PE1ABR mod, after on/off switch flash
over to ground and transformer breakdown
and burnt out due to overvoltage

JRC NBD-500 Power Supply

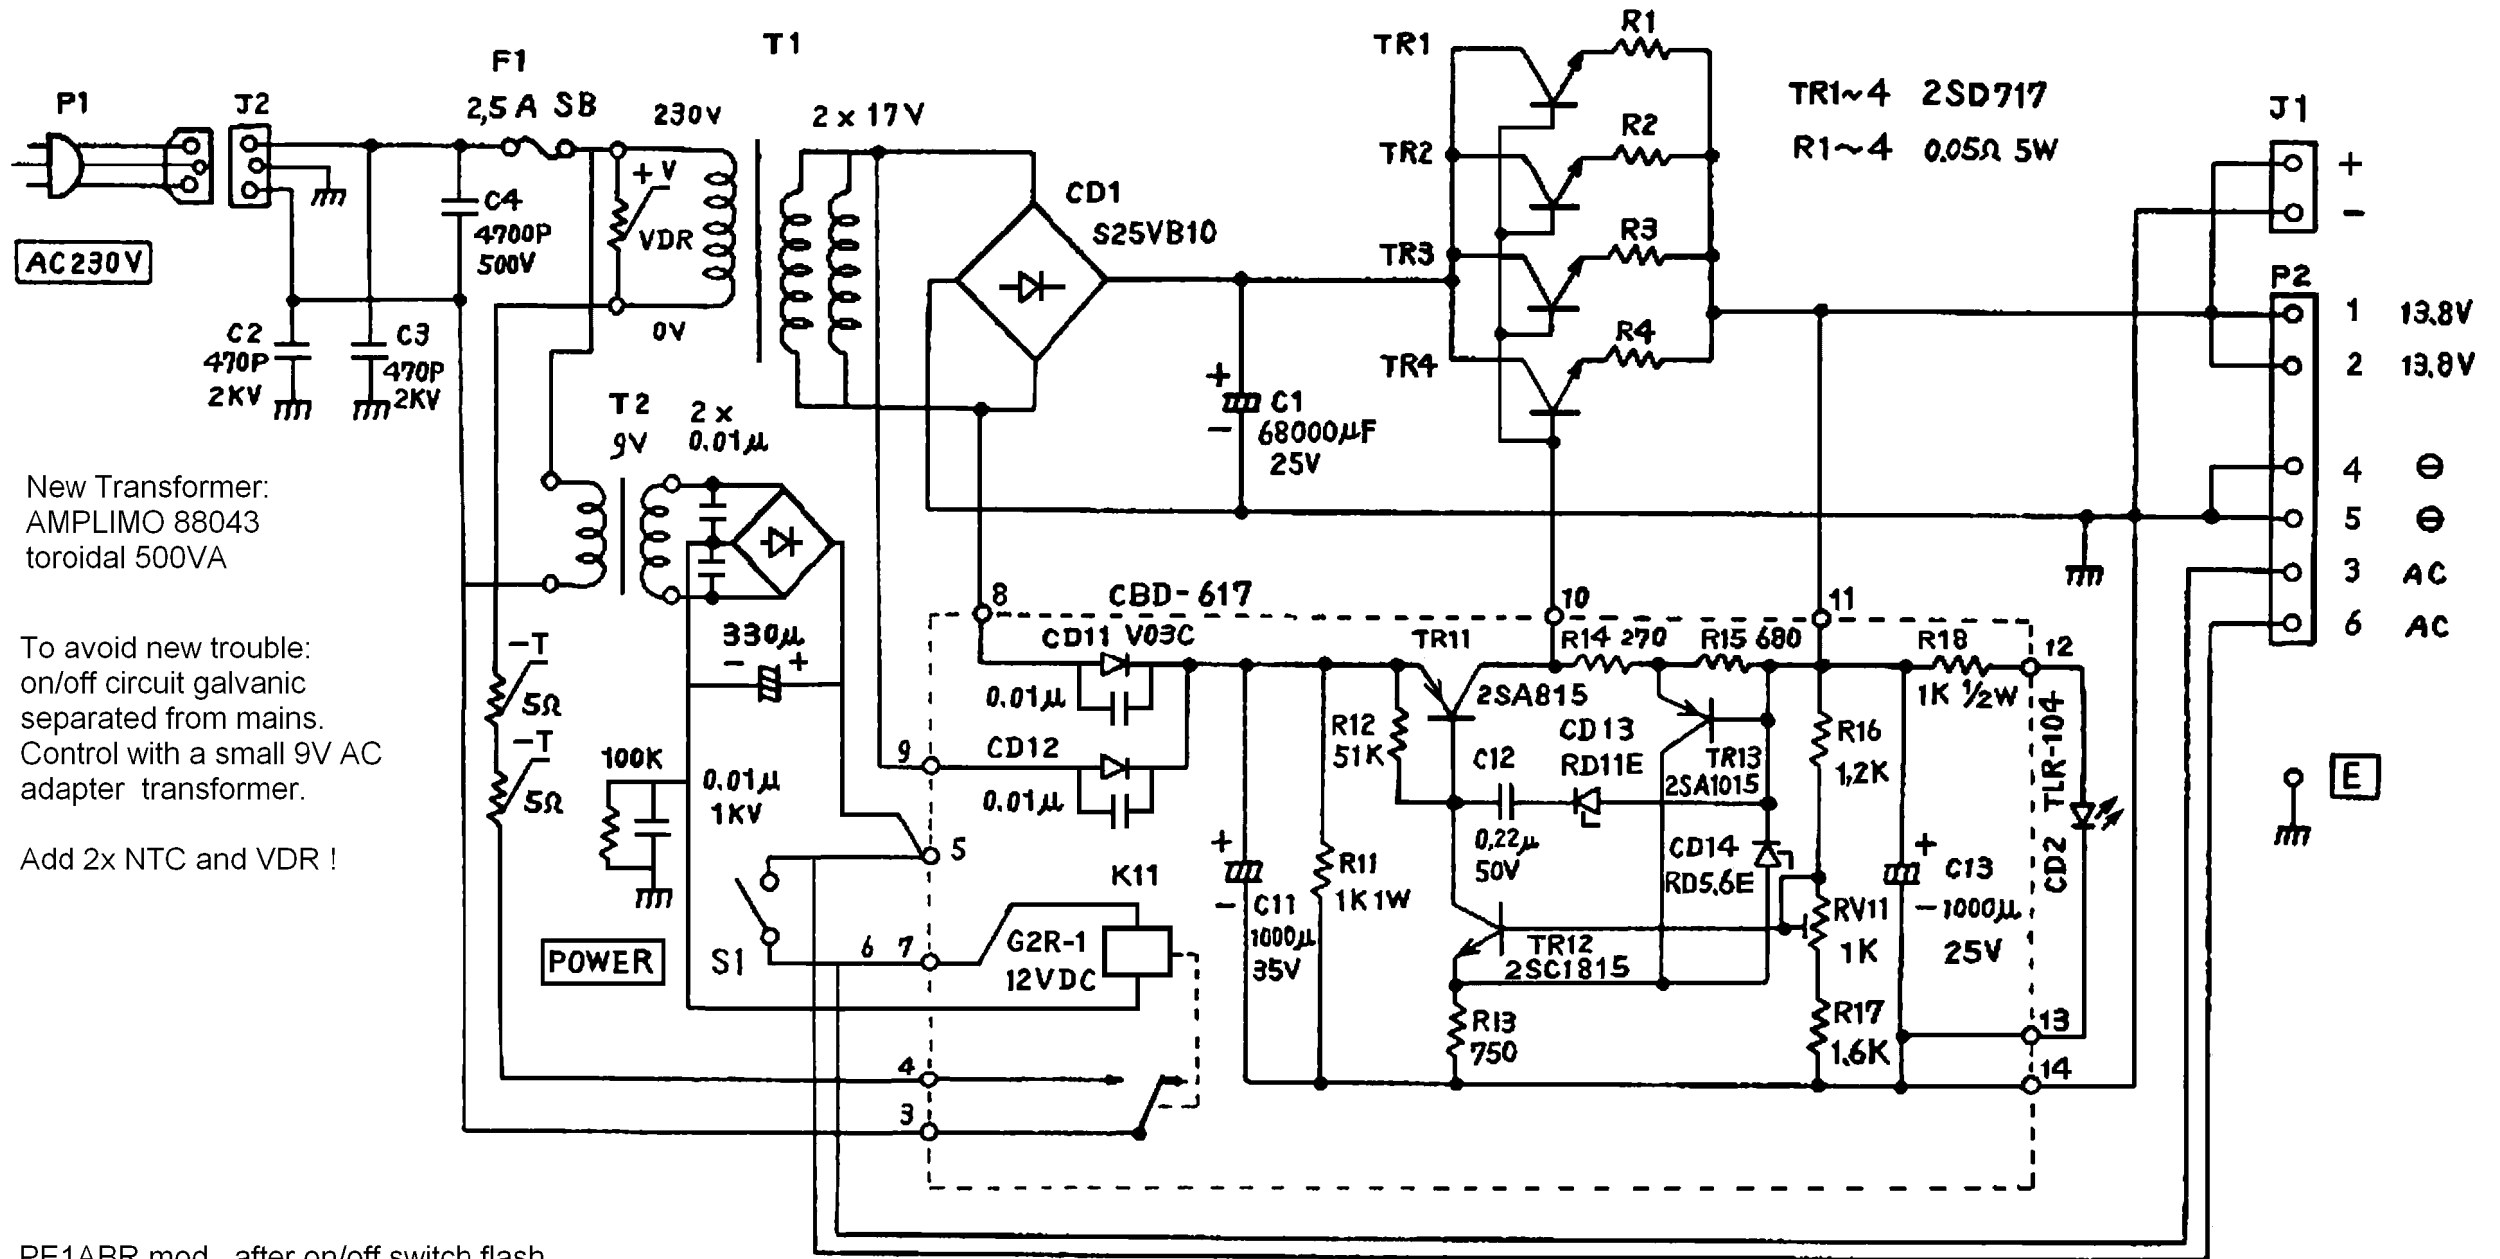
New Transformer:
AMPLIMO 88043
toroidal 500VA

To avoid new trouble:
on/off circuit galvanic
separated from mains.
Control with a small 9V AC
adaptor transformer.

Add 2x NTC and VDR !

If heat becomes too high, add 2 to 3 anti voltage windings
(= 1 to 1,5 V lower output AC)
